Subject: TCS / DSC WARNING LIGHT ON WITH DTC C1956	Bulletin No: 09-004/08
	Last Issued: 01/22/2008

2006-2007 Mazdaspeed6 vehicles with VINs lower than JM1GG****7*110516 (produced before June 6, 2007)

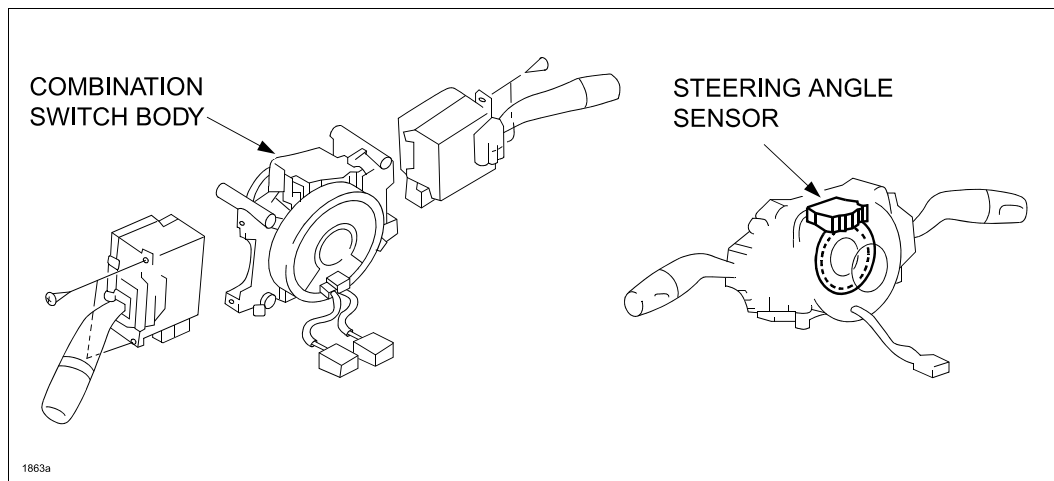
Depending on the size variation in the production of related combination switch parts on the steering shaft, steering angle sensor parts may come in contact with each other causing debris to attach to the steering angle sensor. The debris can cause abnormal signals resulting in a TCS/DSC warning light illumination.

The steering angle sensor assembly in the combination switch body has been modified to avoid interference. Customers having this concern should have their vehicle repaired using the following repair procedure.

1. Verify customer concern.
2. Record customer's preset radio stations, then disconnect negative battery cable.
3. Replace combination switch body with a modified part according to Workshop Manual (section 09-18 COMBINATION SWITCH REMOVAL/INSTALLATION).
